DART SERVICE INSTRUCTION

TO AMEND INSTALLATION INSTRUCTIONS IIN-D407-781-2 REV. A OR LATER APPROVED REVISION
AND INSTRUCTIONS FOR CONTINUED AIRWORTHINESS ICA-D407-781 REV. 3 OR LATER REVISION

A	NEW ISSUE		13.04.08
REV.		DESCRIPTION	BY DATE
DESIGN			
DRAWN			
CHECKED			
MFG. APPR.	N/A		
APPROVED			
DE APPR.			
DATE	13.04.08		
		DART AEROSPACE LTD HAWKESBURY, ONTARIO, CANADA	
		DRAWING NO. DSI 9649	REV. A SHEET 1 OF 2
		TITLE ALTERNATE INSTALL	SCALE NTS
COPYRIGHT © 2013 BY DART AEROSPACE LTD. THIS DOCUMENT IS PRIVATE AND CONFIDENTIAL AND IS SUPPLIED ON THE EXPRESS CONDITION THAT IT IS NOT TO BE USED FOR ANY PURPOSE OR COPIED OR COMMUNICATED TO ANY OTHER PERSON WITHOUT WRITTEN PERMISSION FROM DART AEROSPACE LTD.

Item Name: Baggage Compartment Protector - Floor

**FIGURE 1 - D3879-1 BAGGAGE COMPARTMENT WALL
PROTECTOR - ALTERNATE INSTALLATION**

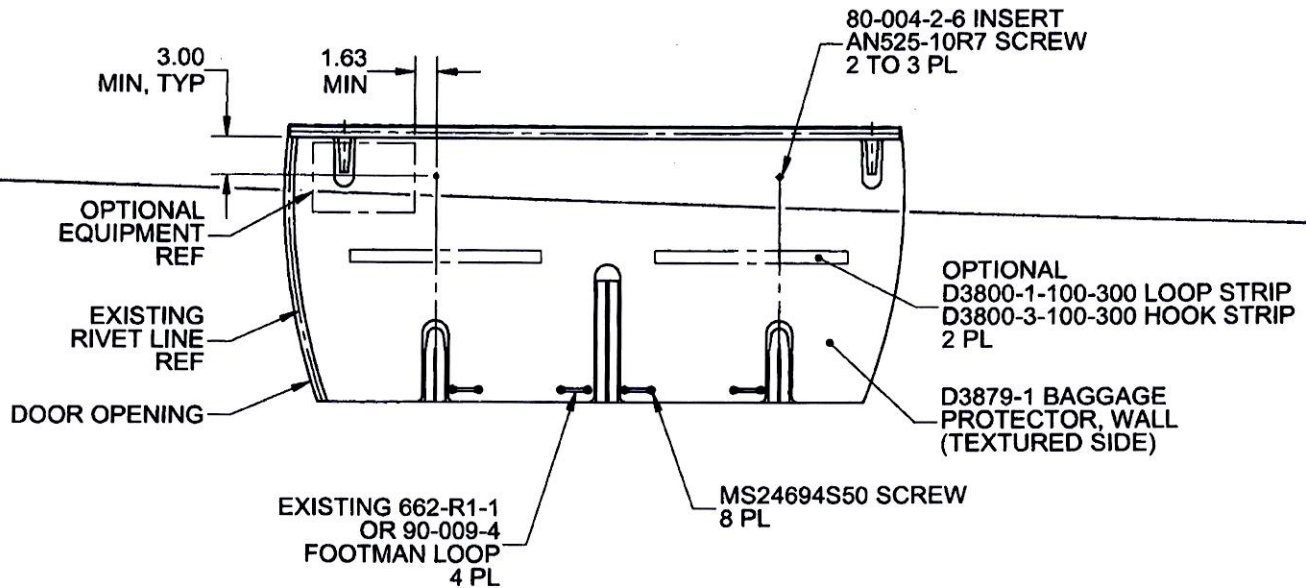
In some aircraft, the top portion of the D206-781-041 Baggage Compartment Wall Protector Kit cannot be installed as indicated in IIN-D407-781-2. The purpose of this DSI is to provide an alternate mounting method to fasten the top portion of the D206-781-041 Baggage Compartment Wall Protector Kit.

It is acceptable to replace qty(2) D3930-1 Clips with qty(2) 80-004-2-6 Inserts. Locate and mark location of the two attachment holes on the baggage compartment wall as shown in Figure 1 of this service instruction. Install 80-004-2-6 Inserts at the marked locations in accordance with Section 3-2-12 of BHT-206-SRM-1. It is acceptable to trim the wall protectors to accommodate optional equipment or transfer attachment holes to the wall protector and install the optional equipment on top of the wall protector with longer fasteners.

Amend the D206-781-041 Baggage Compartment Wall Protector Kit parts list as follows:

Qty -061	Qty -031	Qty -041	Part Number	Description
X			D206-781-061	BAGGAGE COMPARTMENT PROTECTOR KIT (FLOOR AND WALL)
1	X		D206-781-031	BAGGAGE COMPARTMENT FLOOR PROTECTOR KIT
1		X	D206-781-041	BAGGAGE COMPARTMENT WALL PROTECTOR KIT
		2	AN525-10R7	SCREW
		2	80-004-2-6	INSERT
